Serial No.: 09/904,676  
Amendment Dated: September 29, 2003  
Reply to Office Action of April 28, 2003

**AMENDMENTS TO THE DRAWINGS:**

FIG. 1

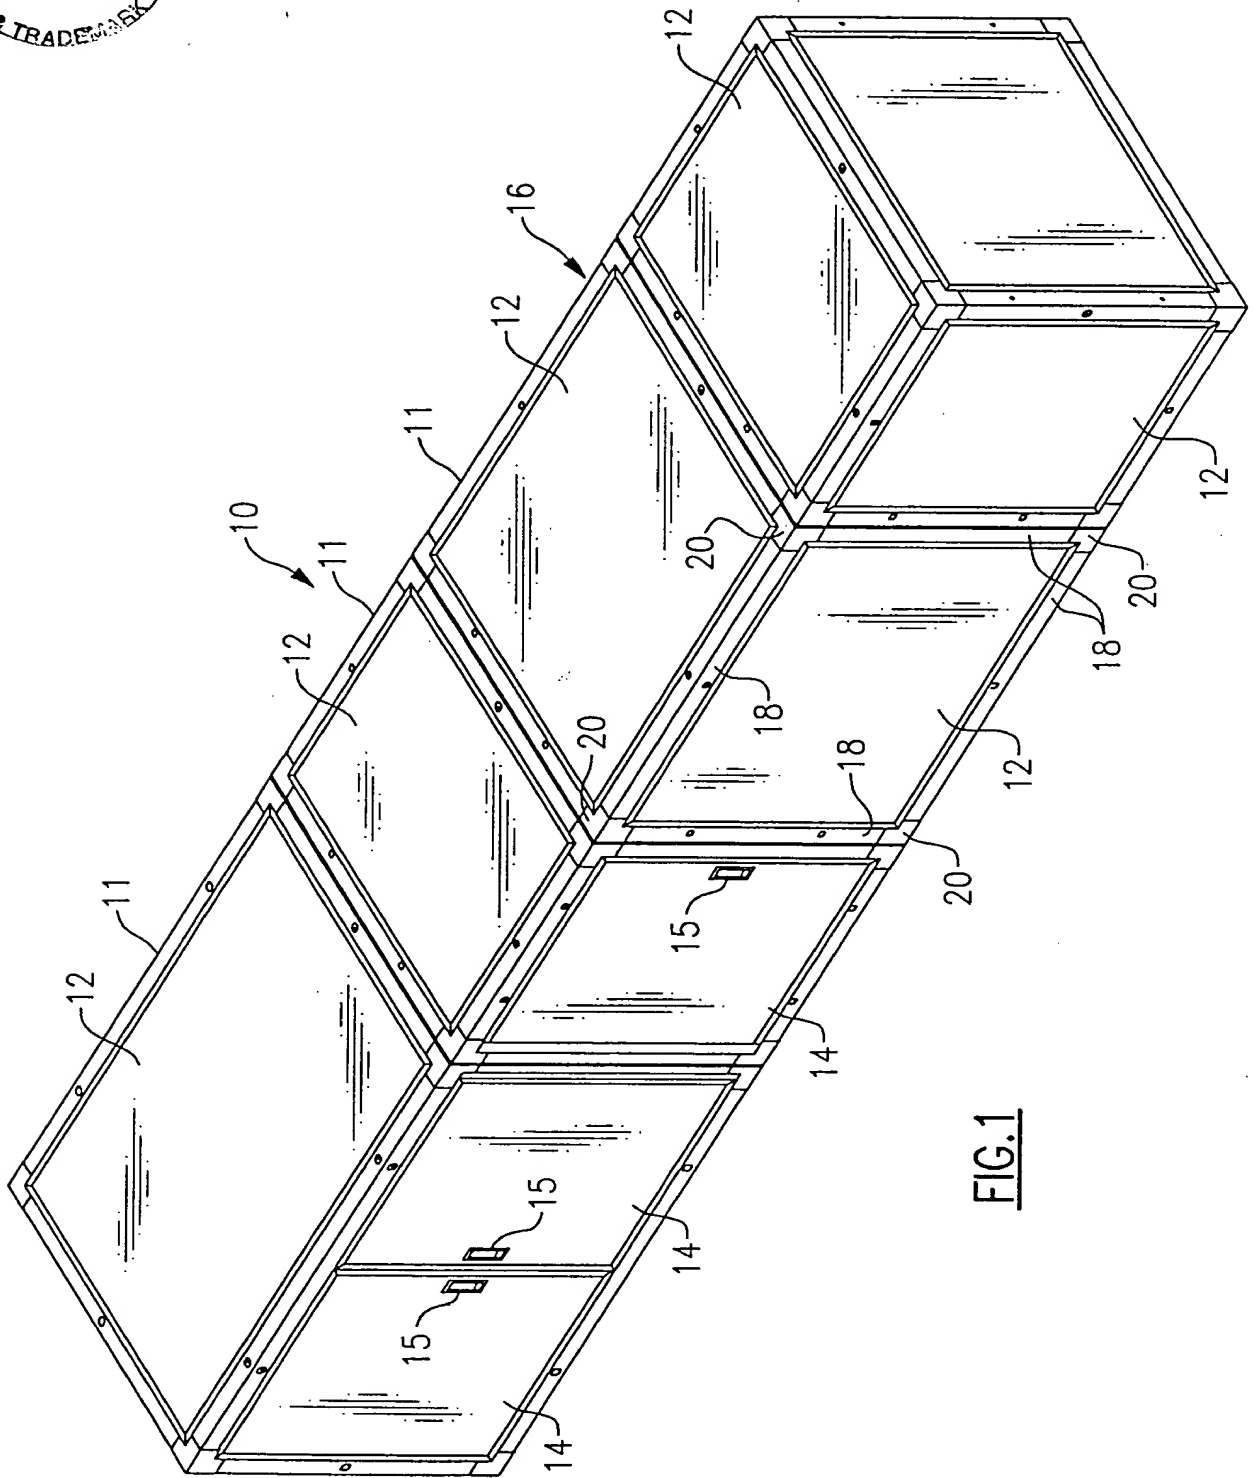
The proposed drawings corrections have been approved. However, the drawings are objected to because of numeral 16 not including an arrowhead. Further, the addition of numerals 11 have been added to accommodate an amendment to the specification. These changes have been incorporated into formal drawings being submitted herewith.
